**SANITARY WARE SPECIFICATION SHEET**

WSD 3321/2024 T/J(1285/2024)

**Approval of "AMERICAN STANDARD" Shower Mixer  
(General Acceptance No. C20250006)**

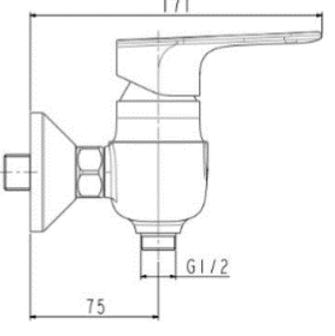
Having considered the test report ref. 222320PC240073 issued on 25 October 2024 by Fugro Technical Services Limited, this Authority accepts that the fitting described below complies with, and its use when correctly installed does not contravene, the Waterworks Ordinance and Regulations.

**Model:** FFAS1712-709XXXBC0  
(where "XXX" denotes the code of colour)

This Authority hereby permits the use of the above fitting in fresh water plumbing systems subject to full adherence to Waterworks installation requirements. In particular, you are required to draw your customers' attention to the following requirement-

"The cold water supply to the fitting shall be drawn from the same source that supplies the hot water apparatus so as to provide a balanced pressure and to obviate the risk of scalding in the event of a restriction or failure in the water supply." AND

"The shower head or handspray should not be placed in submerged conditions and should be securely fixed to the original position after use."

A condition of this acceptance is that the fitting to be installed shall be replicas of the sample as certified by the testing agent mentioned above and without modifications. This acceptance may be withdrawn at any time if the standard of the fitting installed fails to meet that of the approved sample or if the fitting is found to be unsuitable for use in fresh water plumbing systems.

This acceptance is only applicable to the main body of the fitting, unless otherwise specified.
